South Lake Elementary School, Mandatory Referral, MR 2022005

- Mandatory Referral for the construction of a new 106,842-square foot South Lake Elementary School to accommodate 796 students.
- Location: 18201 Contour Road
- Zone: R-200/Montgomery Village Overlay Zone
- Master Plan: 2016 *Montgomery Village Master Plan*
- Size: 10.20 acres
- Application Accepted: August 12, 2021
- Applicant: Montgomery County Public Schools (MCPS)

RE: Mandatory Referral No. MR2020027
Plan & Traffic Impact Study
South Lake Elementary School

Figure 2: Overall South Lake Elementary School Site Plan

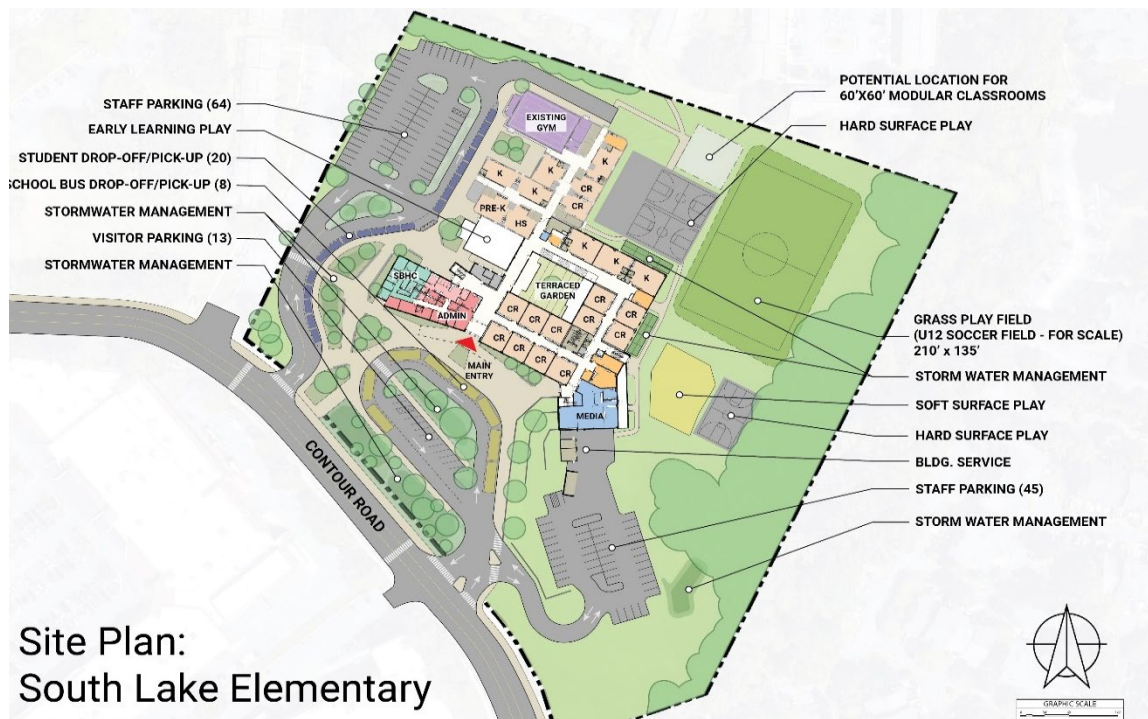
The overall proposed building is approximately 106,842 square feet in size, and it is organized around a central courtyard (Figure 2). The new addition has two levels, taking advantage of the Site's topography (Figure 3). A Pre-Kindergarten play area is west of the courtyard and a public plaza is proposed along the western and southern portions of the addition. The existing athletic field, basketball courts and other play areas will be retained with this proposal.

Figure 4: July 2020 Mandatory Referral Application

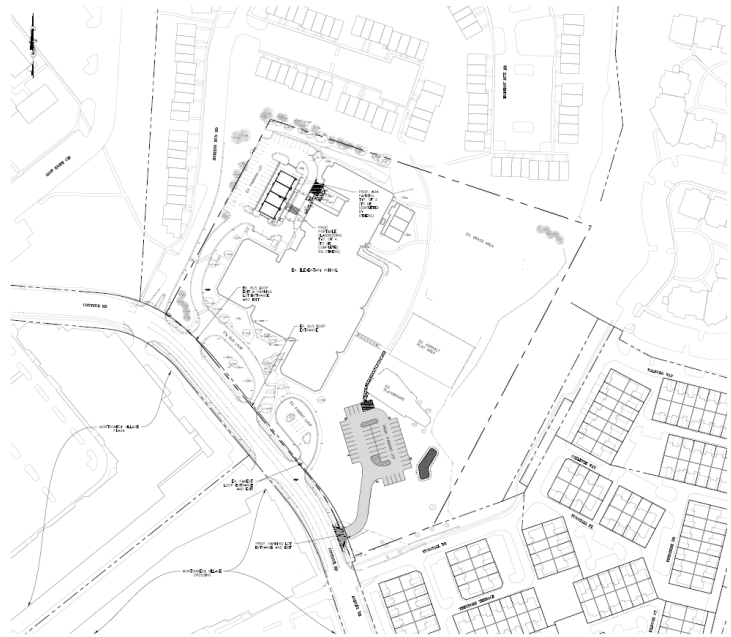
In July 2020, the Planning Board reviewed the Mandatory Referral application (MR2020027) to install a 49-space parking lot on the southeastern portion of the Property and to install four new portable classrooms on a segment of the existing parking lot to address enrollment issues (Figure 4). The Planning staff and Planning Board expressed concern that the parking lot proposal, like other recent MCPS projects, disproportionately emphasized automobile use, by introducing an additional curb cut along Contour Road, as well as additional impervious surfaces on the Property.

Planning staff has collaborated with MCPS to revise the submitted development to address safety concerns for pedestrians and to minimize conflicts between vehicles and pedestrians. Staff also explored consolidating staff parking from two areas into a garage structure; however, this concept is costly to implement, and it would require significant revisions to the proposed building.

Key changes from the initial submission include the following:

1. The access point at the bus loop and the staff parking area has been modified to address safety concerns for pedestrians.

The revised layout improves pedestrian safety and access to the Site. The southeast access point has been reduced to 45 feet, which was previously 64 feet, and the access to the student drop-off area has been reduced to 30 feet in width, rather than 40 feet. Additionally, the proposed curb radii have been tightened to slow vehicle turning speeds across sidewalks traversed by students.

2. The bus loop has been modified with new materials to provide opportunities for alternative uses or activities.
3. New internal raised pedestrian crossings.
4. A new pedestrian path was added to the southeast portion of the Site, and an access gate was added to the staff parking area in the southeast area so that vehicles can be prevented from crossing the walking route to the school during arrival and dismissal.

These modifications, which are shown in Figure 5, contribute to increasing pedestrian safety and minimizing vehicular conflicts with pedestrians.
